Access Compliance Report

Public Rights-of-Way

(Curb Ramps)

Intersection ID: 42723	Main Street: STARGRASS_CT	Cross Street: WAKEROBIN_LN	Location:	N
ADA ID: 75575A2F6748	Ramp Type: PerpDiag	Initial Pass/Fail: Fail	Overall Compliance: No	Severity Score: 8.75
Codes/Mitigation Info/Possible Solution		Field Measurements/Component Compliance

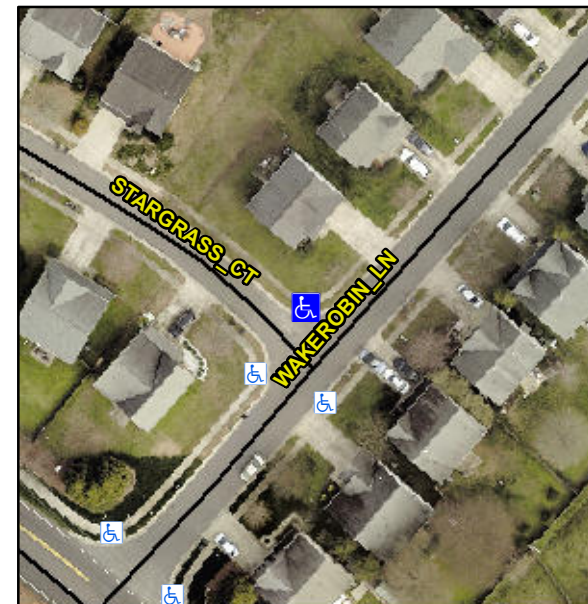
Not Found, R304.5.1

Compliance	Description	Data	Compliance	Description	Data
N/A	Ramp Length (in)	49.0	Yes	Ramp Slope (%)	5.2
No	Ramp Width (in)	41.0	Yes	Ramp XSlope (%)	1.5
N/A	Flare Type LT	N/A	N/A	Flare Type RT	N/A
N/A	Flare Slope LT (%)	N/A	N/A	Flare Slope RT (%)	N/A
N/A	Flare Traversable LT?	N/A	N/A	Flare Traversable RT?	N/A
N/A	Landing Length (in)	N/A	N/A	DWS Provided?	N/A
N/A	Landing Width (in)	N/A	N/A	DWS Contrast?	N/A
N/A	Landing Slope (%)	N/A	N/A	DWS Length (in)	N/A
N/A	Landing X Slope (%)	N/A	N/A	DWS Full Width?	N/A
N/A	Landing Curb? (Y/N)	N/A	N/A	DWS Offset (in)	N/A
N/A	Shared Landing?	N/A			
N/A	Gutter Ponding?	N/A	N/A	Gutter Slope (%)	N/A
N/A	Gutter Lip Ht (in)	N/A	N/A	Gutter X Slope (%)	N/A
N/A	Painted X Walk1?	No	N/A	Painted X Walk2?	No
	X Walk 1 Direction	To SW		X Walk 2 Direction	To SE
N/A	X Walk 1 Width (in)	N/A	N/A	X Walk 2 Width (in)	N/A
	X Walk 1 Slope (%)	1.2		X Walk 2 Slope (%)	3.3
	X Walk 1 X Slope (%)	0.3		X Walk 2 X Slope (%)	2.5

Remove & Replace Curb Ramp With Two New Directional Ramps or Equivalent.
